SERVICE BULLETIN

Service Bulletin No.: D42L-79-01 Rev. 3

Title: Installation of an External Oil Cooler Scoop

3. General: This Service Bulletin gives instructions for the installation of an external oil cooler scoop on the lower cowlings of the DA42 L360 aircraft. Revision 3 adds a drain hole drilled through the NACA Scoop Assembly to permit collected water to drain.

Figure 4 - Oil Cooler Scoop Template Tool

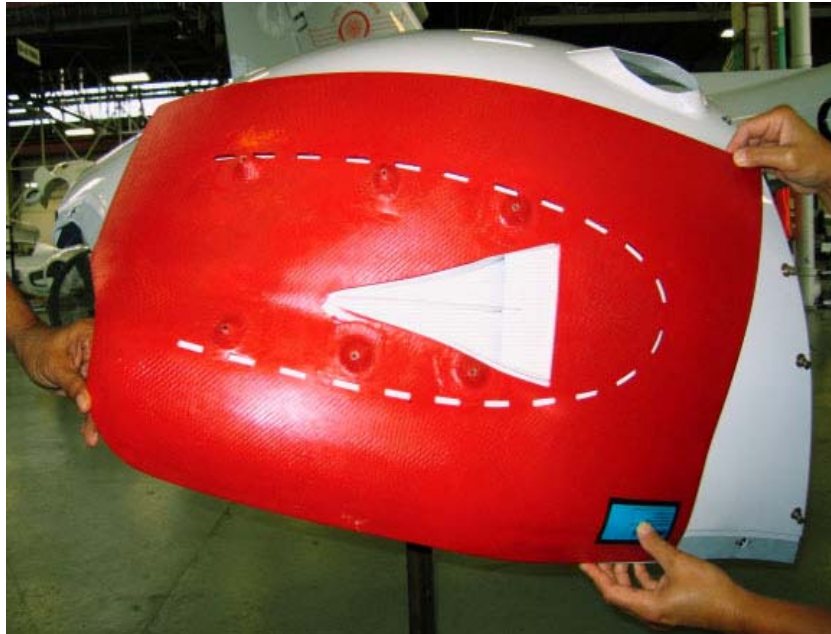
- 10.4 Hold the Oil Cooler Scoop Template Tool (P/N C61-7116-104-105-11-01) tightly against the surface of the lower cowling assembly. Align the cowling's upper rebate with the rebate in the Template Tool as shown in Figure 4.

Figure 5 - Oil Cooler Scoop Template Tool

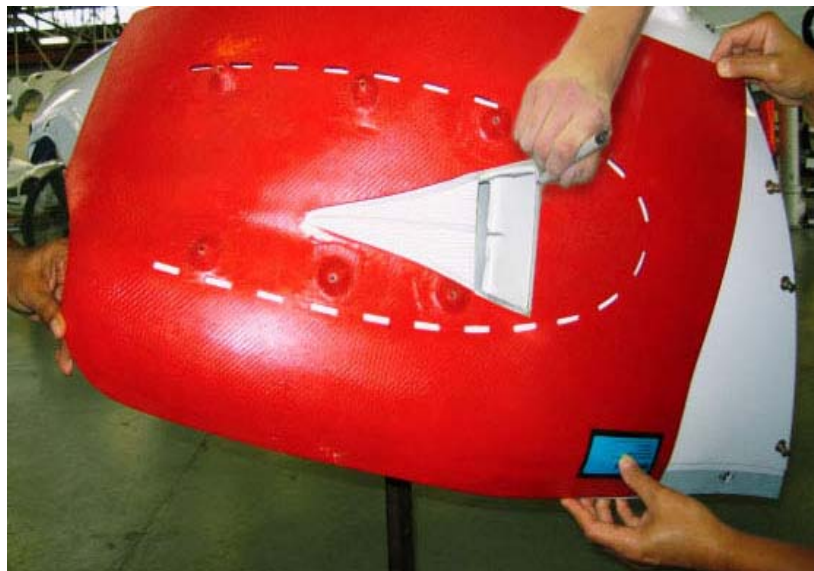
- 10.5 Mark out the NACA aft lip area for removal as indicated in Figure 5.

Figure 10 - Installation of NACA Scoop Assembly

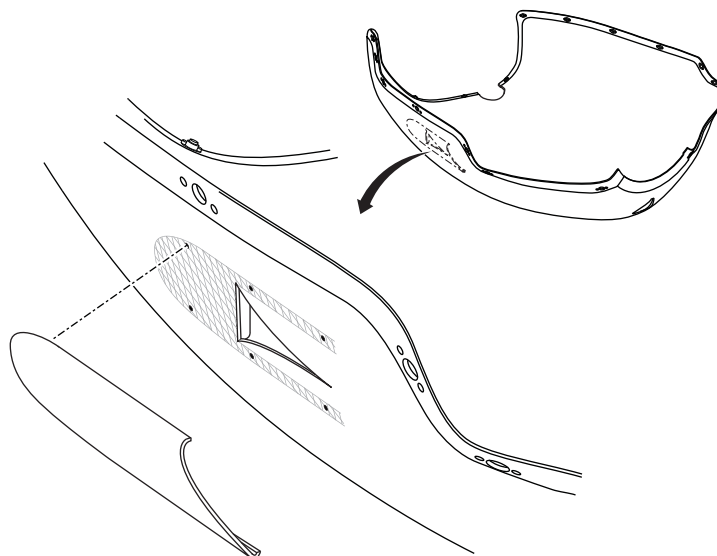
- 10.15 Hold the NACA Scoop Assembly (P/N C61-7116-129-001) provided tightly in place within the removed paint lines and back drill the six 3.2 mm (1/8 inch) holes into the scoop flange. Use Cleco fasteners to hold the NACA Scoop Assembly tightly in place after each hole is drilled (reference Figure 10).

Figure 11 - Drain Hole in the NACA Scoop Assembly

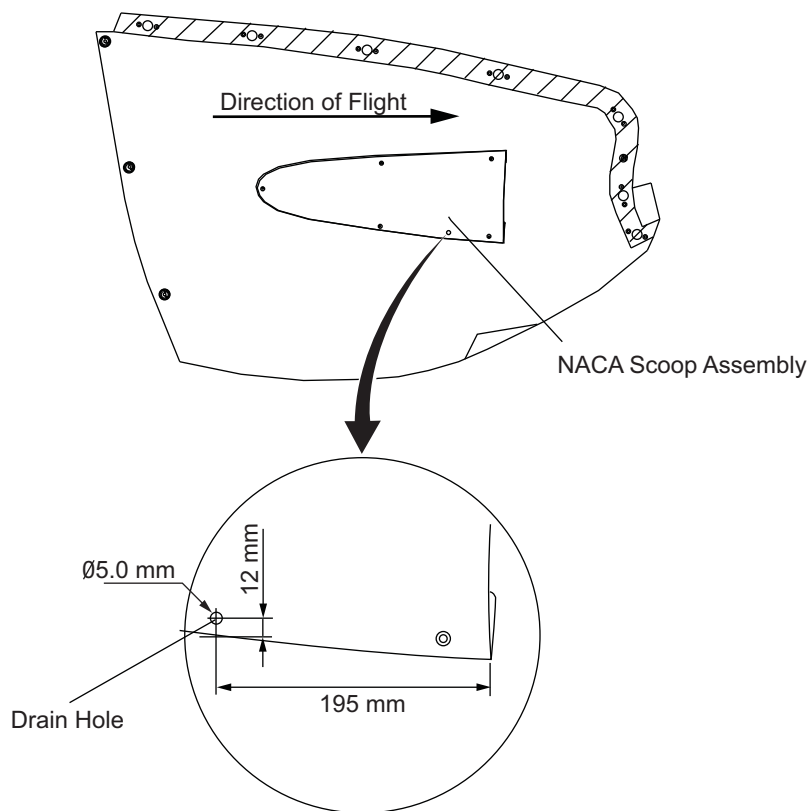
10.16 With the NACA Scoop Assembly tightly in place, use a felt tip marker to mark the lowest point on the scoop where water would collect.

10.18 Drill a 5.0 mm drain hole through the NACA Scoop Assembly at the marked lowest point (reference Figure 11).

NOTE: This will permit the water that collects in the NACA Scoop Assembly to drain.

Figure 12 - Winter Kit Assembly Fit

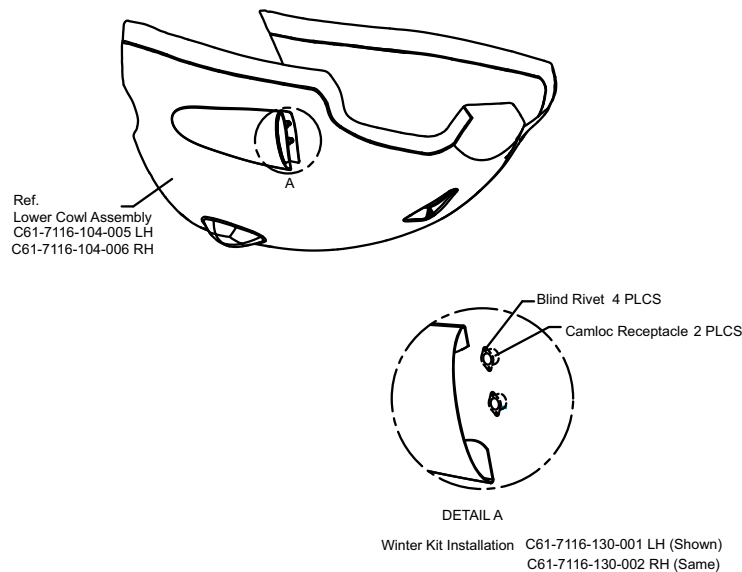
- 10.33 Fit/align the Winter Kit Assembly against the top forward edge of the NACA Scoop Assembly (reference Figure 12). Outline the two CAMLOC wing stud holes onto the lower cowling.

NOTE: It will be necessary to remove the two CAMLOC wing studs from the Winter Kit assembly before locating the holes in the lower cowling.
